PLANNING COMMISSION
Meeting Agenda
Monday – January 11, 2016
7:00 PM
City Council Chambers – 155 NW 2nd Avenue

SITE AND DESIGN REVIEW/CONDITIONAL USE PERMIT STAFF REPORT
FILE #: DR 15-07/CUP 15-04, PREMIER GEAR
PREPARED FOR THE JANUARY 11, 2015 PLANNING COMMISSION MEETING

LOCATION: 387 S Sequoia Parkway

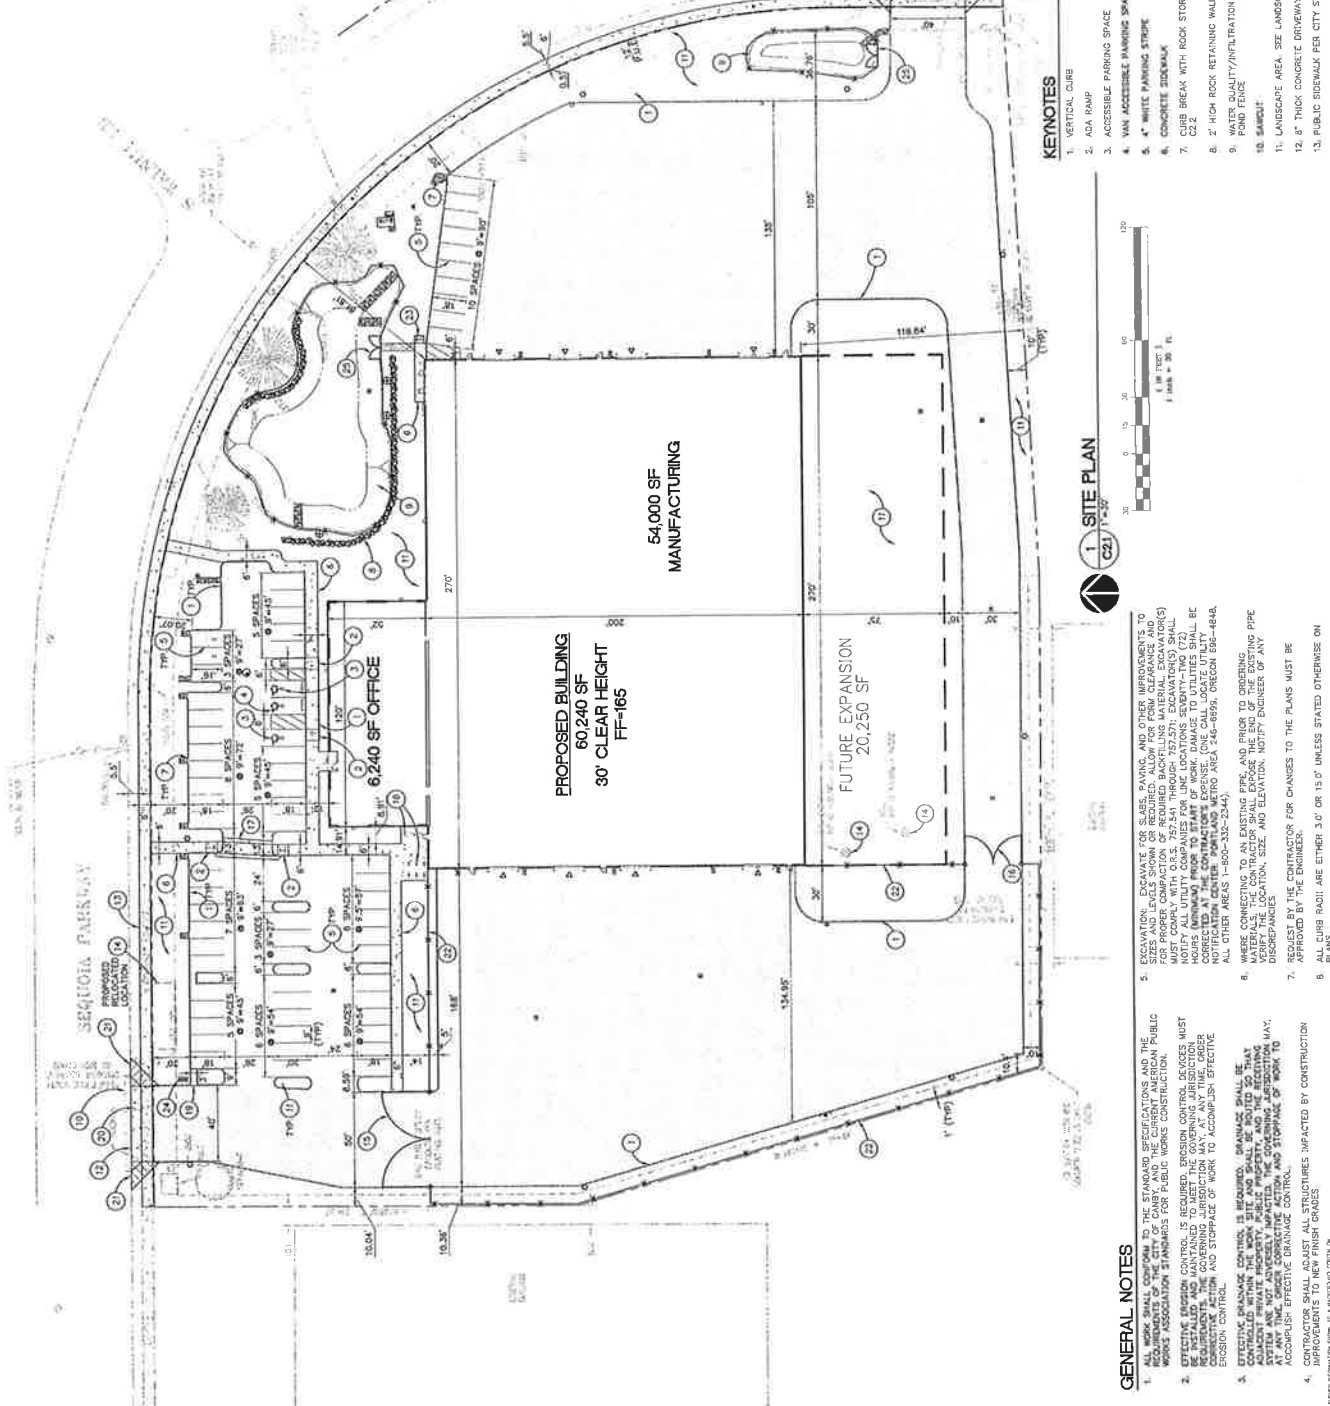
3. A 6-foot wide concrete sidewalk will be required along the entire site frontage with a 5-foot wide planter strip. The submitted site plan (Sheet C2.1) reflects this requirement.
